**To:** Docketing Division  
**From:** George Martin, Grade Crossing Planner, Rail Division  
**Re:** In the matter of the authorization of the Ohio Central Railroad and CSX Transportation to install active grade crossing warning devices Tuscarawas and Wood Counties  
**Date:** August 25, 2016

PUCO Case No. 16- 1791 -RR-FED In the matter of the authorization of the Ohio Central Railroad and CSX Transportation to install active grade crossing warning devices in Tuscarawas and Wood Counties

**TO:** Randall Schumacher, Supervisor, Rail Division, PUCO  
**FROM:** Cathy Stout, Manager, Safety Section, ORDC  
**BY:** James Tucker, Safety Project Manager ORDC  
**SUBJECT:** Tuscarawas County, TR656/Schrock Rd.  
DOT# 474241X, PID# 100023.  
**DATE:** August 22, 2016

**TO:** Randall Schumacher, Supervisor, Rail Division, PUCO  
**FROM:** Cathy Stout, Manager, Safety Section, ORDC  
**BY:** Don Damron, Project Manager, ORDC  
**SUBJECT:** Wood County, TR 96, Green Rd. / CSX Transportation  
DOT# 155802  
PID# 102020  
**DATE:** August 25, 2016

# Field Sketch

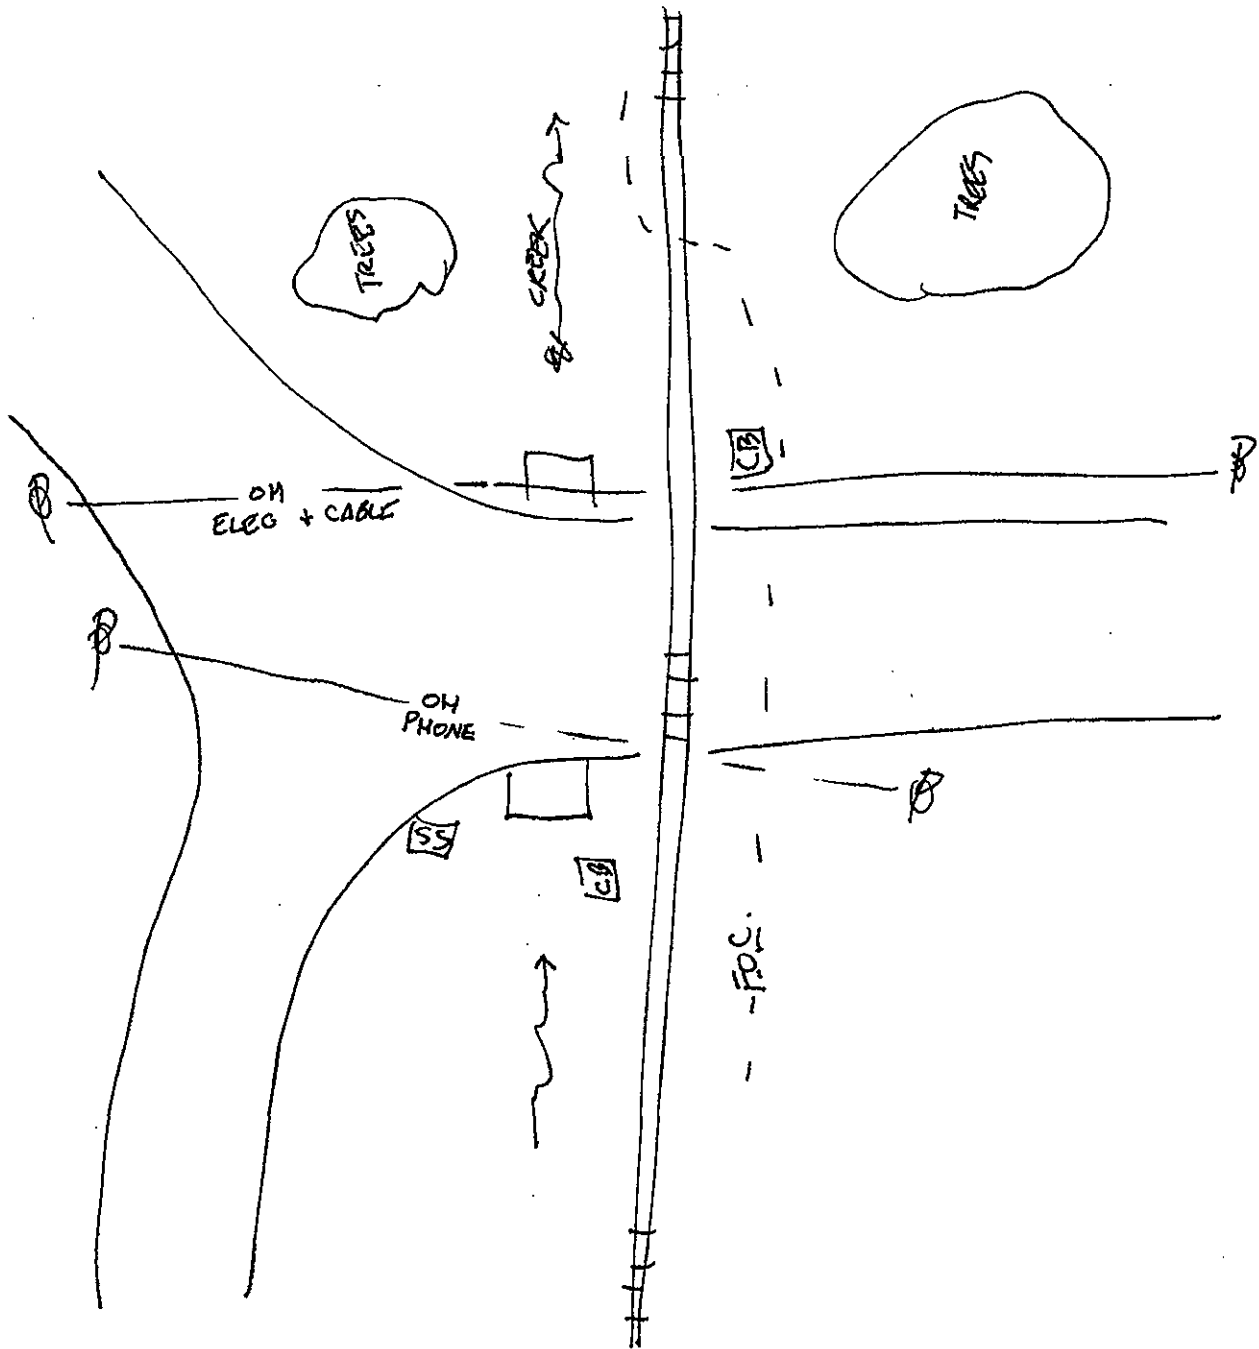
Big Pipe 36"?

- No resources available to get new ADT. Due to hazard ranking and visibility at the crossing install L&A. cms 3/24/15

Field Sketch

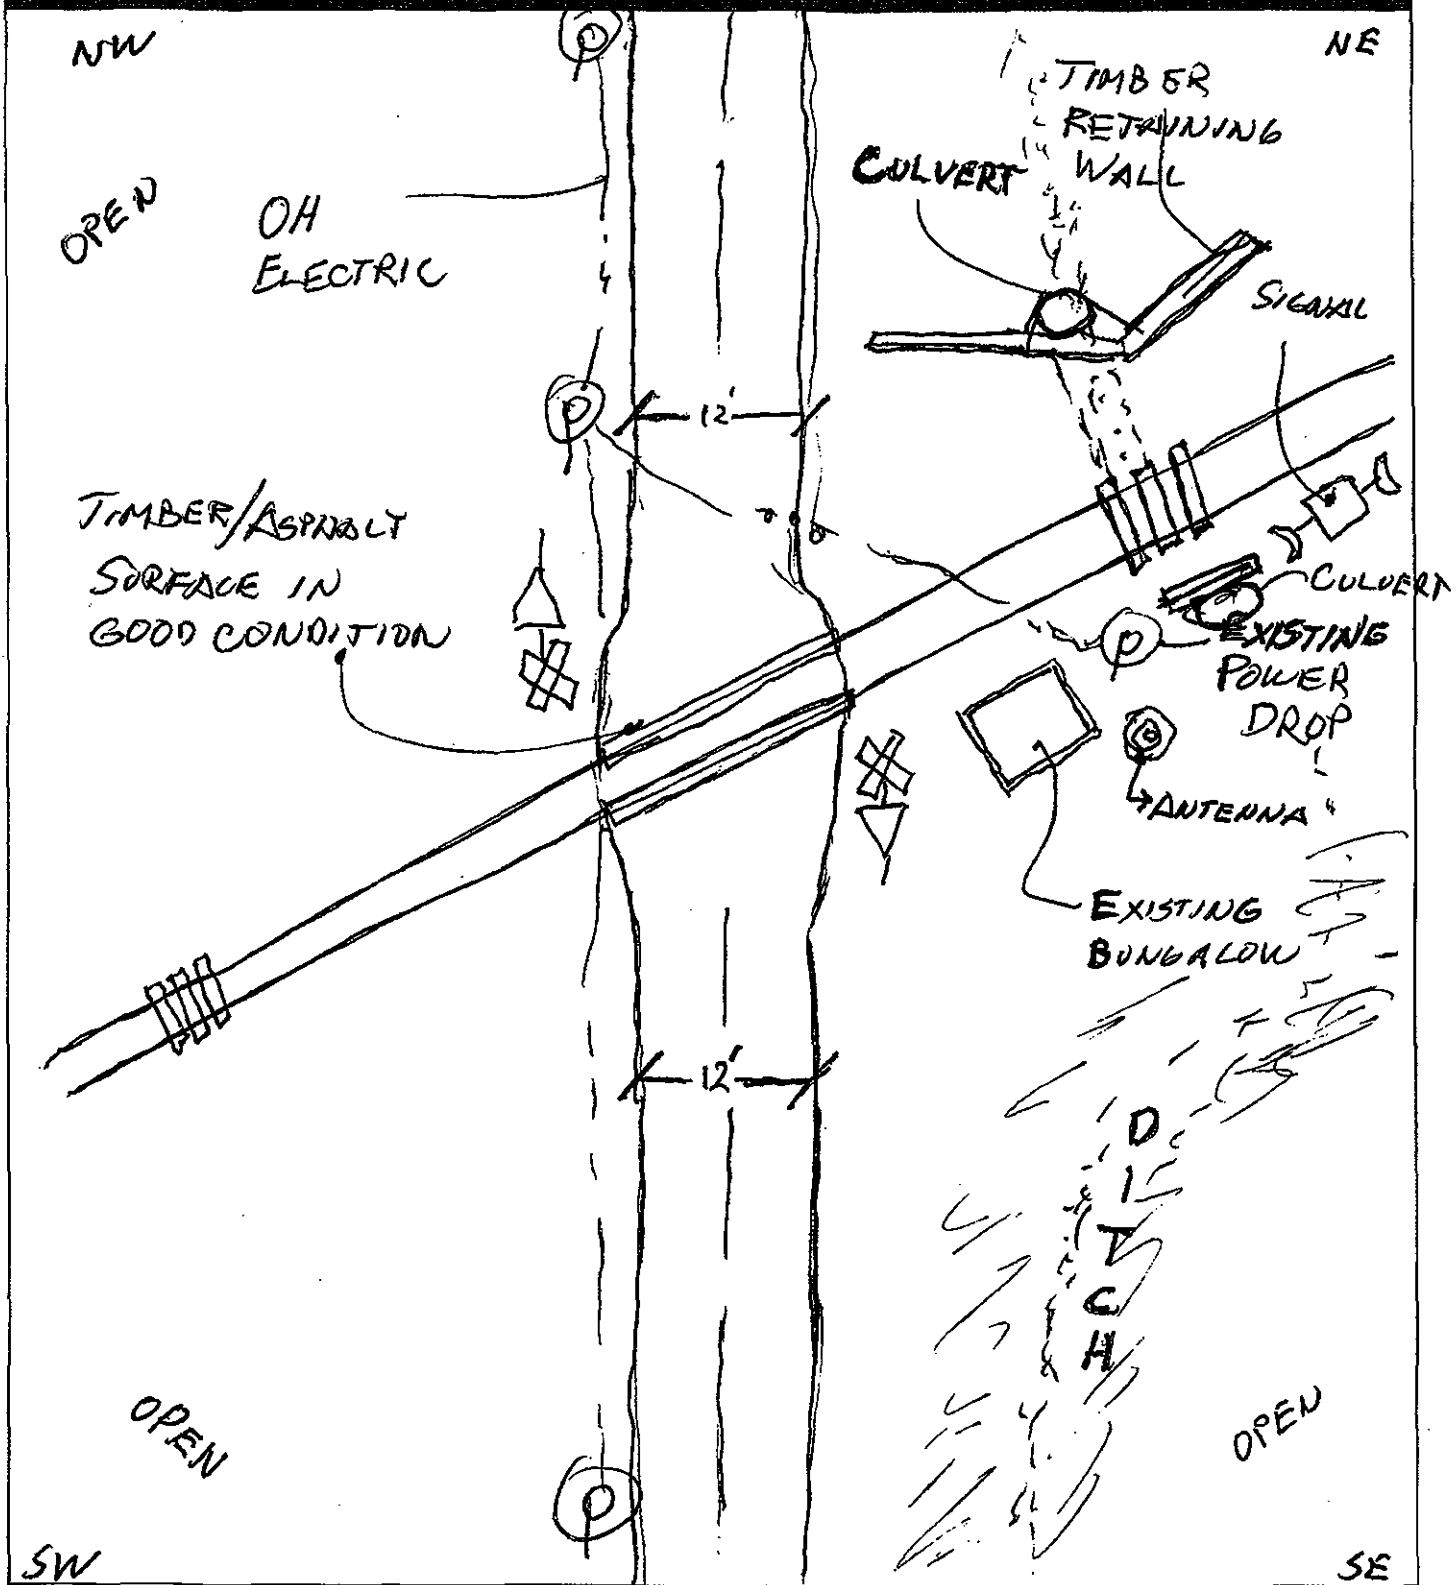
If non-gated crossing, is clearing sight distance adequate in all quadrants? (See Table 1) ☐ Yes ☒ No **BUNBALOW OBSTRUCTION**

Culverts / Drainage / Ballast Conditions: WOOD RETAINING WALLS AND  
CULVERT IN NE QUAD IN ROUGH SHAPE.

EXISTING SIGNAL HOUSE IN SE QUAD TOO CLOSE TO ROAD.

**"UPGRADE WARNING DEVICES TO LIGHTS AND GATES"**

Field Sketch

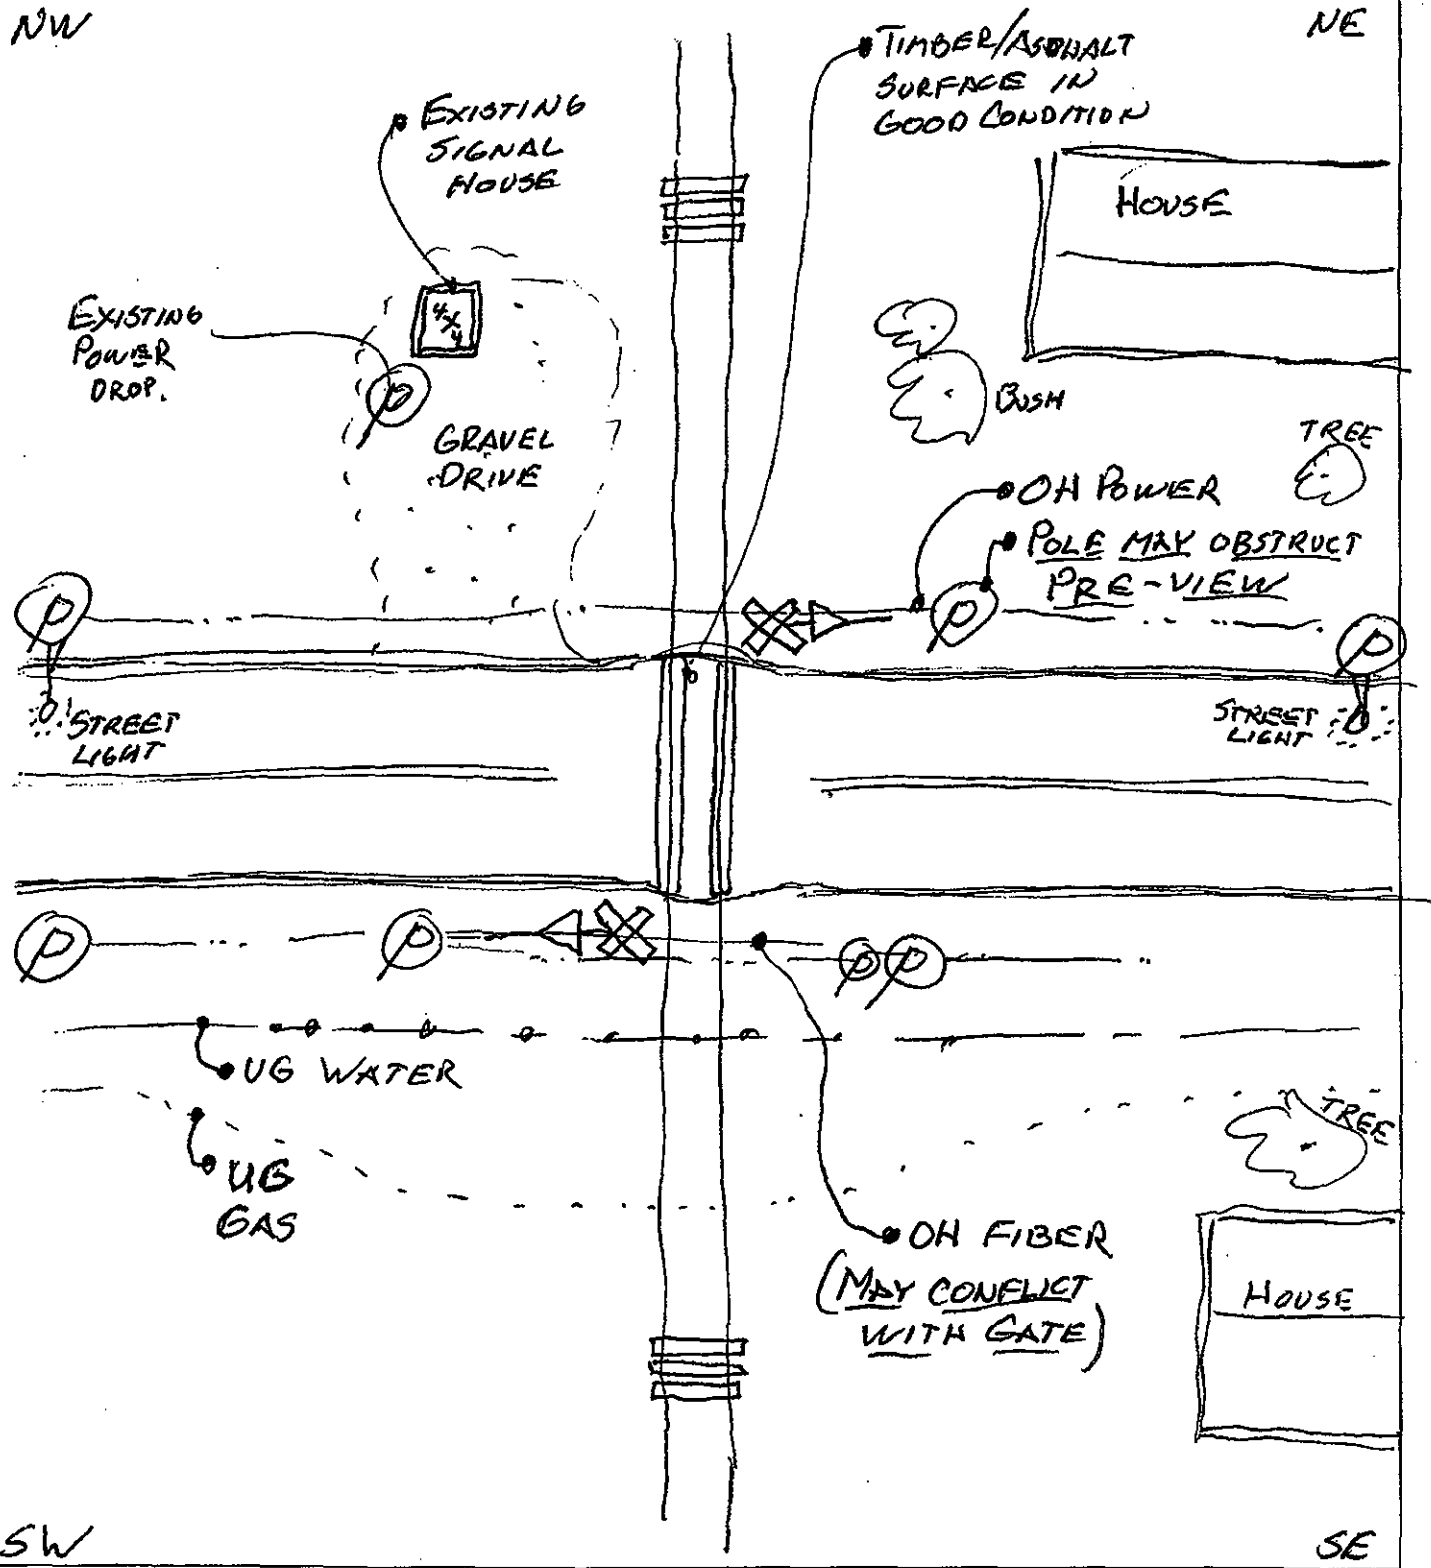
What other utilities are present? <input checked="" type="checkbox"/> Gas <u>UG</u> <input type="checkbox"/> Cable <input type="checkbox"/> Telephone <input type="checkbox"/> Fiber Optic Cable (add locations to sketch) <input type="checkbox"/> Petroleum <input type="checkbox"/> Water <input type="checkbox"/> Sanitary Sewer <input type="checkbox"/> Other _____	
Is(are) there potential utility conflict(s) <input checked="" type="checkbox"/> Yes <input type="checkbox"/> No <input type="checkbox"/> Unknown	
Comments: <div style="border: 1px solid black; padding: 10px; margin-top: 10px;"> <ul style="list-style-type: none"> <li>• UG COLUMBIA GAS LINE ALONG SOUTH SIDE OF MERMILL RD.</li> <li>• UG FIBER ALONG EAST SIDE OF RR TRACKS APPROX 12' FROM TRACK CENTER</li> <li>• UG GAS IS APPROX 20' FROM EDGE OF ROADWAY IN SW QUAD.</li> <li>• OH CABLE + POWER MAY NEED TO BE RELOCATED</li> <li>• POWER POLE IN NE QUAD MAY OBSTRUCT PRE-VIEW.</li> </ul> </div>

ROADWAY = 80' (CENTER LINE OF ROW @ SOUTH EOR)  
RAILROAD = ~~100'~~ 80' CONFIRMED BY CO. ENG.

INTERMEDIATE SIGNALS (SIGNAL HOUSE)

Comments: **CONSENSUS: "UPGRADE WARNING DEVICES TO LIGHTS AND GATES"**
